NYSERDA's Views on the Preliminary Draft Decommissioning EIS

for the
West Valley Citizen Task Force

August 23, 2006

New York State Energy Research and Development Authority

SIBERIA Prediction 10,000 years from now - Gullies are gone and landscape is "rounded"

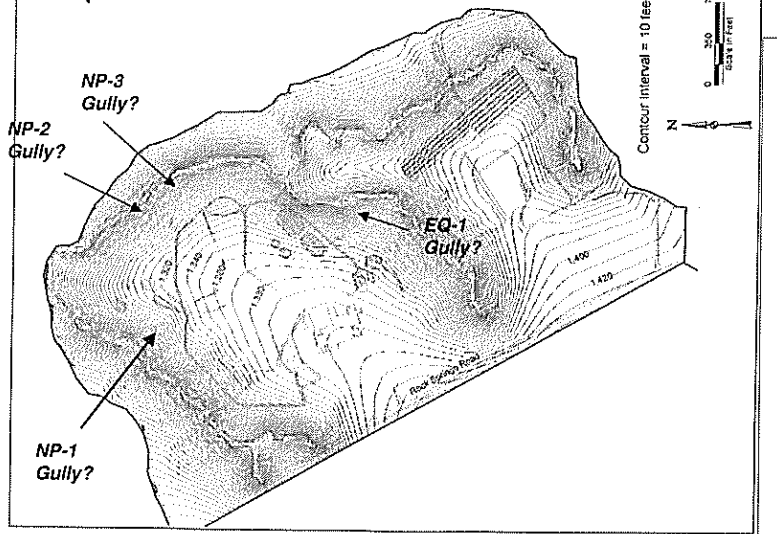
Did not produce credible landscapes

Lack of confidence in the SIBERIA erosion model as a predictive tool for the West Valley site.

Based on the work to date, NYSERDA has no confidence in the long-term predictive ability of SIBERIA for the West Valley site; and

SIBERIA Prediction 1000 years from now - No further headward advance of streams

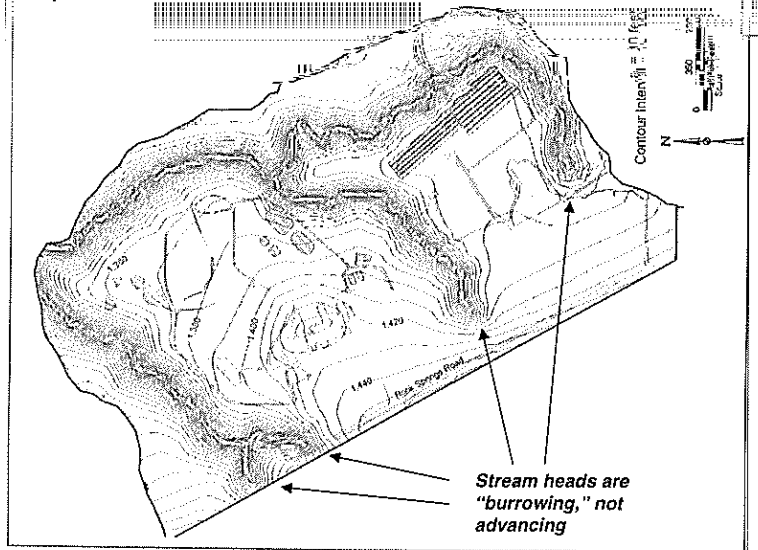
Stream heads are "burrowing," not advancing

Approx. 2 mi. To the nearest receptor

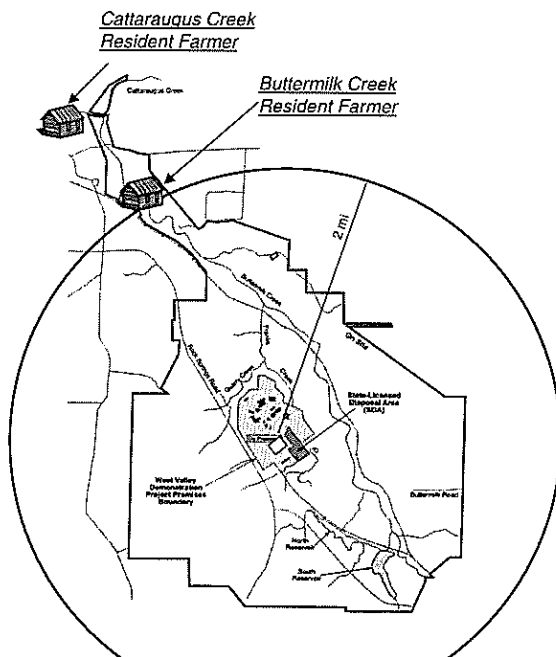
No Residents on the
North or South Plateau
in the erosion analysis.

The nearest resident farmer for the erosion exposure scenario is placed on Buttermilk Creek, 2 miles away from the major contamination sources.

There is no reasonable justification for locating the nearest resident 2 miles away from the site facilities. The analysis must include resident farmers living near erosion-impacted facilities.

Current Site Topography

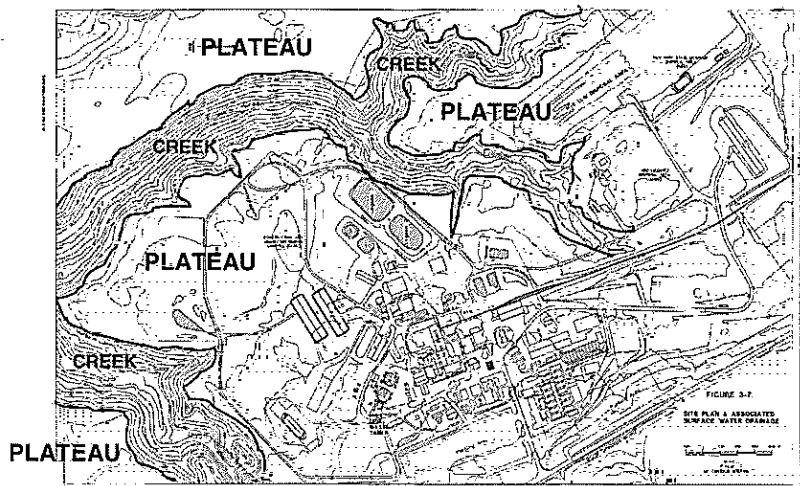
EIS assumes that erosion will generate slopes too steep for a residence or for farming...

in the real world, we see flat lying plateaus next to eroding creeks and gullies

HOME ON EDGE OF CREEK BANK,
CONNOISARAULEY CREEK, NEFF ROAD,
ASHFORD, NY

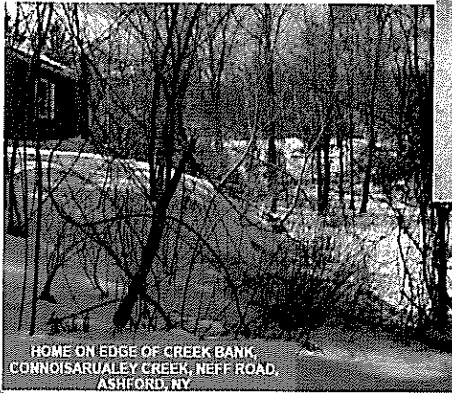
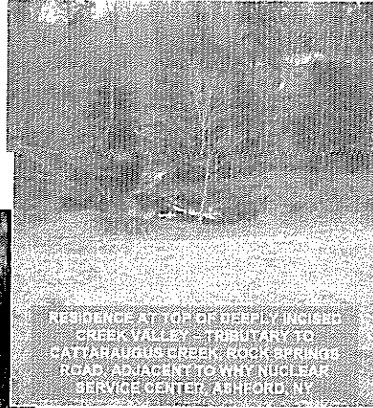
There are homes on flat areas next to erosion features...

People live, farm and work next to erosion areas today, so the EIS should assume people will do the same in the future.

FARM BUILDINGS ADJACENT TO AN
ERODING CREEK - TRIBUTARY TO
CONNOISARAULEY CREEK ALONG
RT. 218, ASHFORD, NY

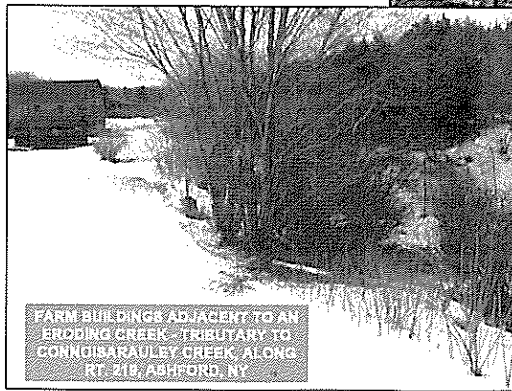
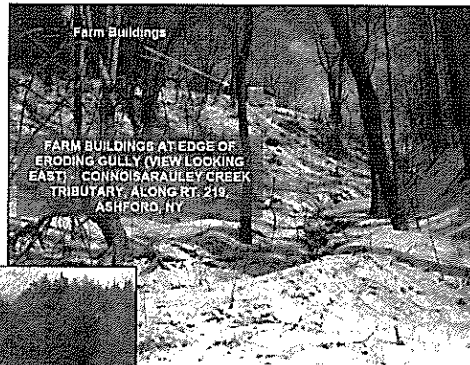
There are farms on flat areas next to erosion features...

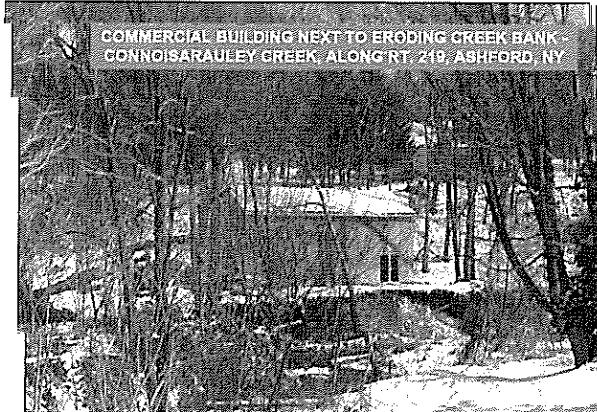
There are other types of structures on flat areas next to erosion features.
